Access Compliance Report

Public Rights-of-Way

Intersection ID: 32165	Main Street: FOLIO CLUB DR	Cross Street: MARIE ROGET WY	Location: E
ADA ID: 0D5F1F157A31	Ramp Type: PerpDiag	Initial Pass/Fail: Fail	Overall Compliance: No
		Severity Score: 8.75

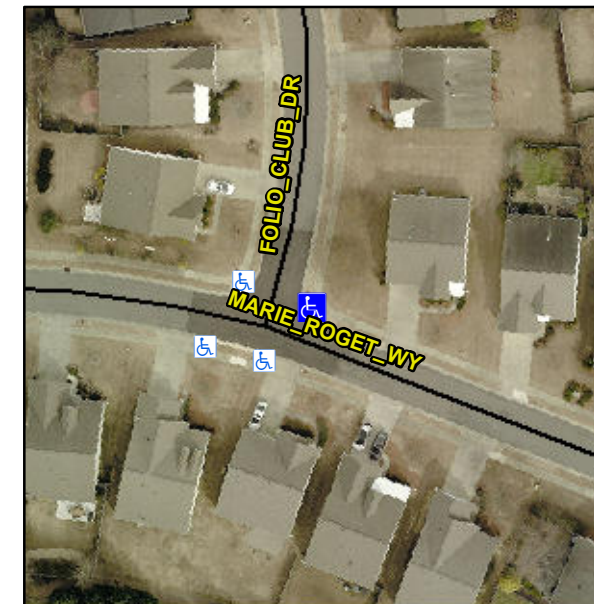
Not Found, R304.5.1

Compliance	Description	Data	Compliance	Description	Data
N/A	Ramp Length (in)	48.0	Yes	Ramp Slope (%)	5.4
No	Ramp Width (in)	38.0	Yes	Ramp XSlope (%)	0.0
N/A	Flare Type LT	N/A	N/A	Flare Type RT	N/A
N/A	Flare Slope LT (%)	N/A	N/A	Flare Slope RT (%)	N/A
N/A	Flare Traversable LT?	N/A	N/A	Flare Traversable RT?	N/A
N/A	Landing Length (in)	N/A	N/A	DWS Provided?	N/A
N/A	Landing Width (in)	N/A	N/A	DWS Contrast?	N/A
N/A	Landing Slope (%)	N/A	N/A	DWS Length (in)	N/A
N/A	Landing X Slope (%)	N/A	N/A	DWS Full Width?	N/A
N/A	Landing Curb? (Y/N)	N/A	N/A	DWS Offset (in)	N/A
N/A	Shared Landing?	N/A			
N/A	Gutter Ponding?	N/A	N/A	Gutter Slope (%)	N/A
N/A	Gutter Lip Ht (in)	N/A	N/A	Gutter X Slope (%)	N/A
N/A	Painted X Walk1?	No	N/A	Painted X Walk2?	No
	X Walk 1 Direction	To NW		X Walk 2 Direction	To SW
N/A	X Walk 1 Width (in)	N/A	N/A	X Walk 2 Width (in)	N/A
	X Walk 1 Slope (%)	3.2		X Walk 2 Slope (%)	0.1
	X Walk 1 X Slope (%)	2.0		X Walk 2 X Slope (%)	2.2

Remove & Replace Curb Ramp With Two New Directional Ramps or Equivalent.
